## Development Management Officer Report Committee Application

<b>Summary</b>	
<b>Committee Meeting Date:</b> 29 <sup>th</sup> June 2023	
<b>Application ID:</b> LA04/2022/0118/F	
<b>Proposal:</b> The proposed erection of 46No.apartment units of traditional construction over three story's, with associated car parking site and landscaping works and the alteration of an existing vehicular access.	<b>Location:</b> 146 Parkgate Avenue, Strandtown, Belfast BT4 1JD.
<b>Referral Route:</b> Paragraph 3.8.2 (a) (i) of the Scheme of Delegation (scheme of more than 12 units with recommendation to refuse and representations in support having been received).	
<b>Recommendation:</b>	Refusal
<b>Applicant Name and Address:</b> Parkgate Property Developments Ltd 17 Mound Road Dromore BT25 1DL	<b>Agent Name and Address:</b> Rolston Architects 49 Lisleen Road Belfast BT5 7SU
<p><b>Executive Summary:</b></p> <p>This application seeks full planning permission for the erection of 46No.apartment units over three storeys, with associated car parking site and landscaping works and the alteration of an existing vehicular access.</p> <p>The key issues are:</p> <ul style="list-style-type: none"> <li>• Princip

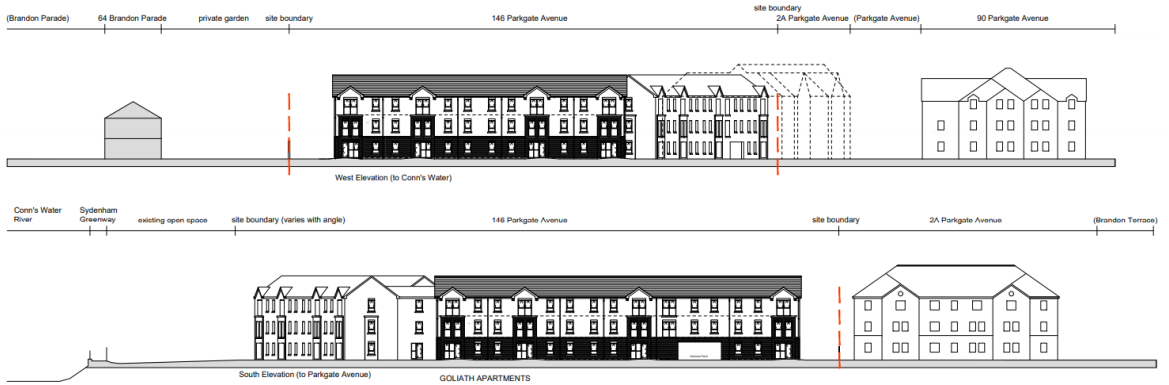
6.23	<p>The two buildings range between approximately 38m and 48m in length. This design approach would result in a monolithic type of massing which is out of character with the area and contextually inappropriate. The scale of the buildings, in combination with the proportions and massing, fails to respect the existing streetscape. The applicant has argued that the proposal fits comfortably within the context of the area and neighbouring buildings, however, it is considered that the length and massing is inappropriate to the scale of the street. Whilst the area contains several apartment developments they are not of a similar scale in terms of length and resulting massing. When read as an entity a proposal of this scale in the local context is an indicator of overdevelopment. The extensive length and massing of the proposal is considered to represent significant overdevelopment of the site. Whilst three storey building height is present in the area, these buildings have restricted plots resulting in limited visual impacts and do not therefore support the design approach of the proposal. Amenity provision space is substandard and will be assessed later in the report. The proposal is contrary to the SPPS, Policy DES1 (a), (j) and (k) and Policy RD1 (a), (b), (d), (g) of the LDP Plan Strategy 2035 in that the development does not respect the surrounding context and is inappropriate to the character of the locality in terms of layout, scale, proportions, massing and appearance of buildings and if permitted would result in overdevelopment of the site.</p>

6.24	<p><b><u>Impact on Amenity</u></b></p> <p>Whilst a 3 storey height forms part of the character of the area, the design and layout of the proposal in proximity to an existing apartment development at No. 2a Brandon Parade creates an unacceptable relationship and will have a detrimental impact on the residential amenity of existing residents. The 3-storey element and roof height create dominant bulk and massing due to its close proximity to the apartment development at No.2a Brandon Terrace. It would appear as a dominant and overbearing feature creating overshadowing due to its height in the street scene which is indicative of overdevelopment, and it would impact on the neighbouring residential amenity of neighbouring properties. However, the separation distance between the two buildings would be 6m, and the dominance created would be unacceptable.</p>

**Image1:**

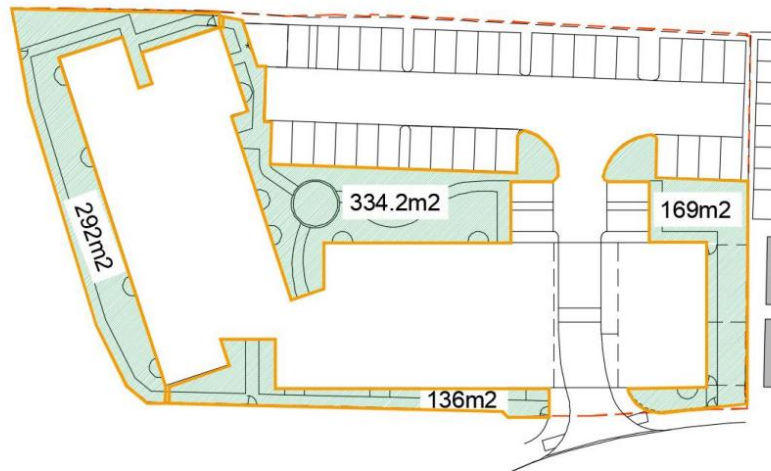
The agent indicated on a site layout plan that 931sqm of communal open space has been provided within the site as illustrated in the first image below (Image 1). The agent later claimed that 1,993sqm of open space was being offered through the development (Image 2). This included car parking areas and is not considered to be an accurate reflection of the quantum of communal open space. A figure of approximately 931sqm of communal open space is considered to be accurate.
